SPECIAL USE EXCEPTION PETITION

**Petition Number:** SUE-25-02

**Project Name:** Inca Maya Restaurant

**Requested Action:** SUE-25-02 Special Use Exception, for a restaurant with front yard parking, outside seating and the sale of alcoholic beverages at 15270 Manchester Road.  
[per Appendix A, Article XIV, Section 1 (14) (20) & (21)]

SHEET TITLE:  
**SITE PLANS, OUTDOOR DINING PLAN, TRELIS FRAMING PLAN**

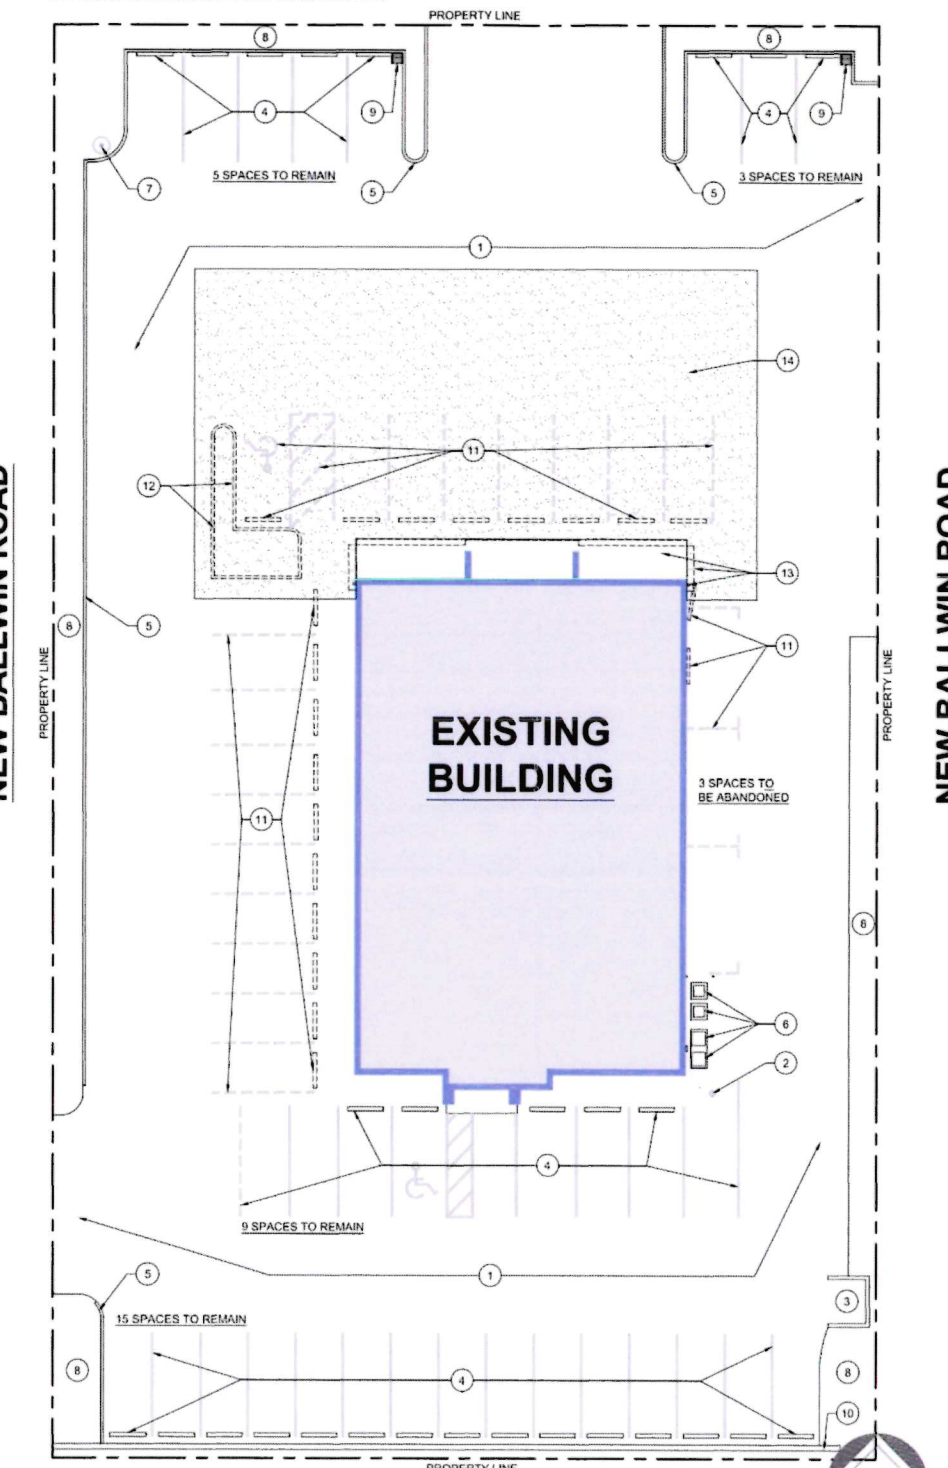
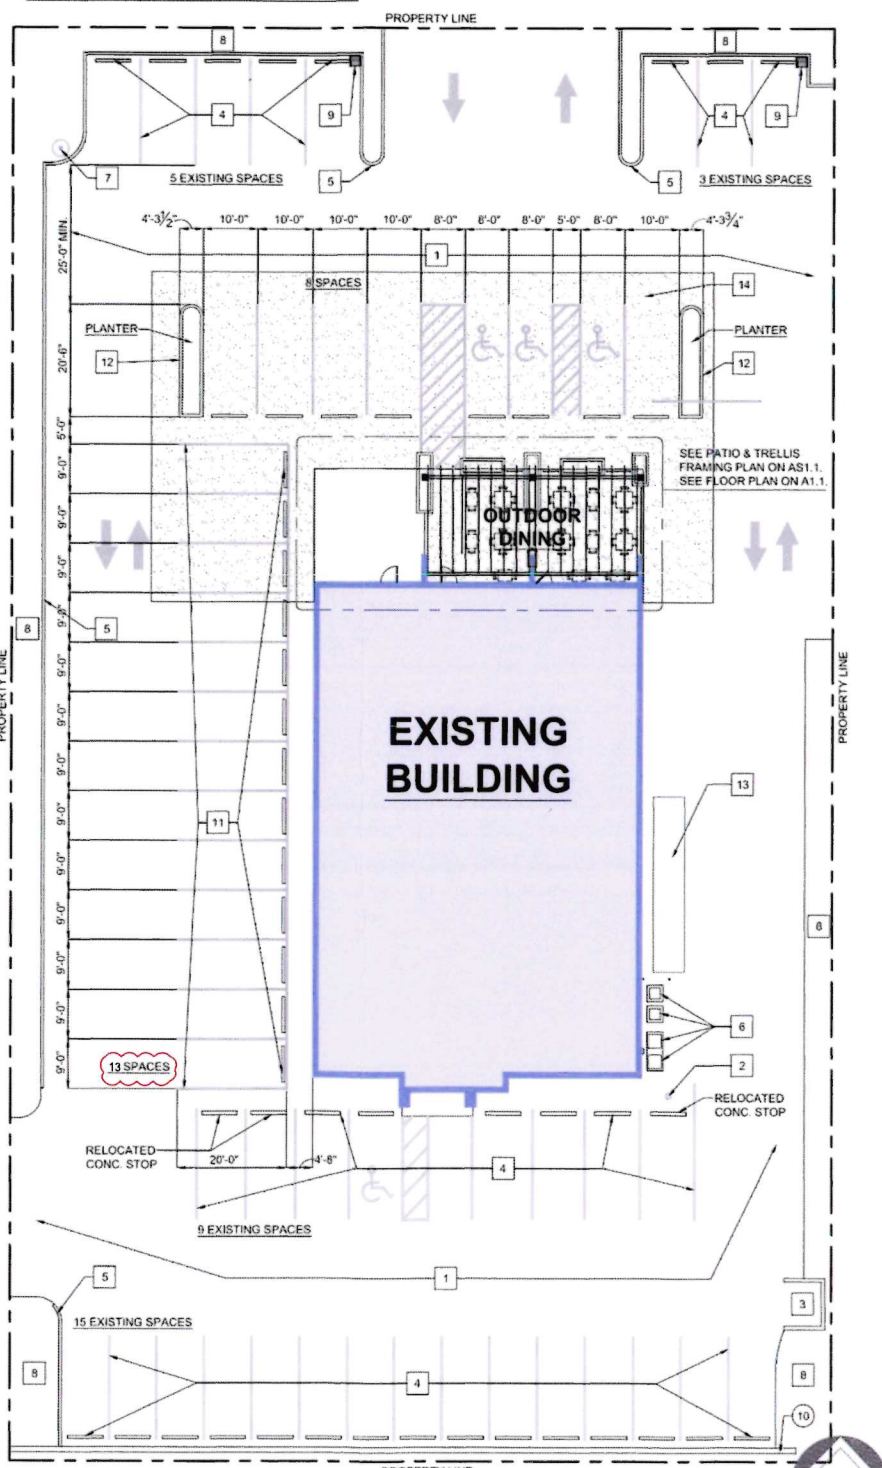
It occurred to me that Article XV, Section 1, Para. 2, Line 4 does not apply as the number of existing parking spaces has been reduced rather than increased. My apologies for the misinterpretation and any inconvenience this may have caused. I have revised Required Parking Data (submitted earlier this evening) as follows:

**Revised Required Parking Data:**

**Inca Maya Restaurant:** 33 parking spaces ( Article XV, Section 1, Para. 1, Line 16: 1 parking space per 4 restaurant seats. Note this is a greater number than 1 space per 200 sq. ft. as the restaurant is approximately 3,240 sq. ft.)

**Unoccupied Suite 110:** 5 parking spaces (Assume Wholesale Establishment per Article XV, Section 1, Para. 1, Line 23: 1 parking space per 300 sq. ft. for 1,610 sq. ft.)

**Unoccupied Second Story:** 15 parking spaces (Assume Wholesale Establishment per Article XV, Section 1, Para. 1, Line 23: 1 parking space per 300 sq. Ft. for 4,450 sq. ft.)

**Total Required Parking Spaces: 53** Attached sheet AS1.1 has been revised to reflect above changes.
